## Model Series 167: ARTICO Seat Covers On Front Seat Torn/Cracked

Topic number LI91.18-P-071629

Version 8

Function group 91.18 - Seat covers

Example 3

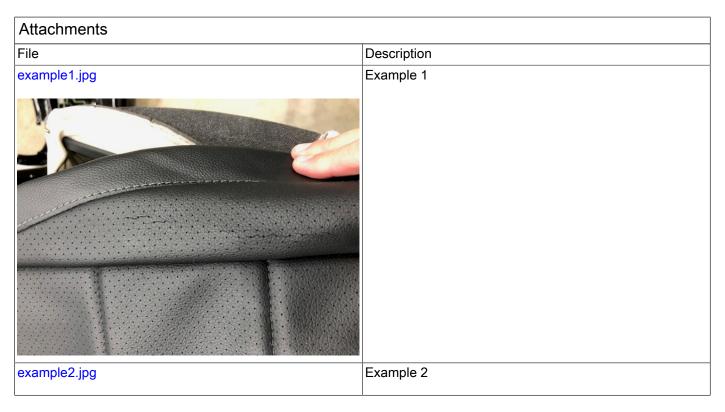
On vehicles with "ARTICO man-made leather upholstery" or "ARTICO man-made leather upholstery / DINAMICA microfiber - black (601A)" the material of the seat side bolster can tear. Both the seat cushion cover and the backrest cover on the front seat can be affected here.

The material may tear because the material in the side bolster is not suitable.

Optimized seat covers are now available for ordering with new part numbers.
